RECALL CAMPAIGN BULLETIN

NTB15-003

VOLUNTARY SAFETY RECALL CAMPAIGN 2014 – 2015 ROGUE AND PATHFINDER FRONT HUB AND TORQUE MEMBER BOLT TORQUE

APPLIED VEHICLES: 2014 – 2015 Rogue (T32)
2014 – 2015 Pathfinder (R52)

Figure 1

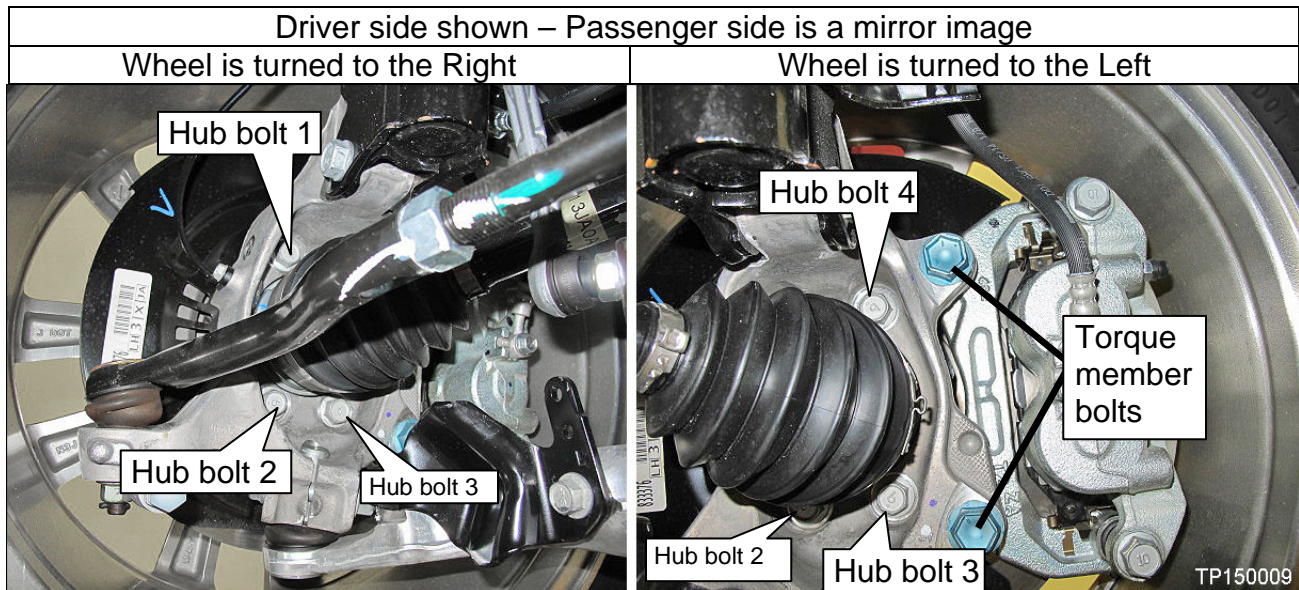
1. Lift the vehicle.
2. Locate and torque the 4 hub bolts and 2 torque member bolts on each front wheel hub assembly (see Figure 1).

Hub bolts: Torque to 88.3 N·m (9.0 kg-m, **65 ft-lb**).

Torque member bolts:

Pathfinder - torque to 123 N·m (13.0 kg-m, **91 ft-lb**).

Rogue - torque to 165 N·m (17.0 kg-m, **122 ft-lb**).

NOTE: Make sure to perform the above torque procedure on BOTH (driver and passenger side) front hub assemblies.

Figure 2

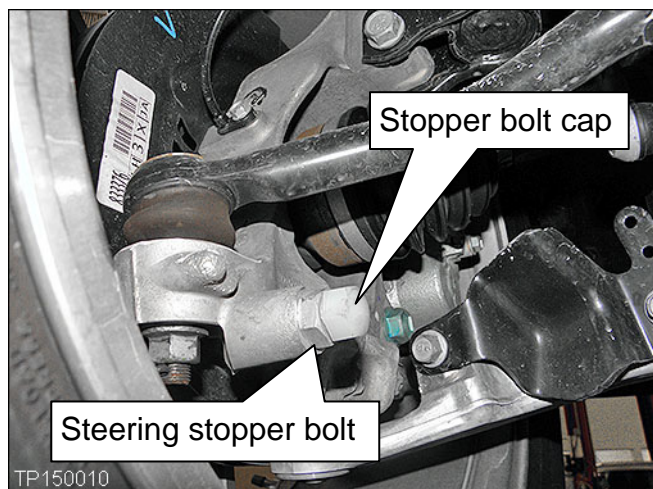
3. **For Pathfinder only:**

Torque the steering stopper bolts (both sides) to 63 N·m (6.4 kg-m, **46 ft-lb**).

- A 19 mm deep socket will fit over the stopper bolt cap.
- Make sure to perform the above torque procedure on BOTH (driver and passenger side).
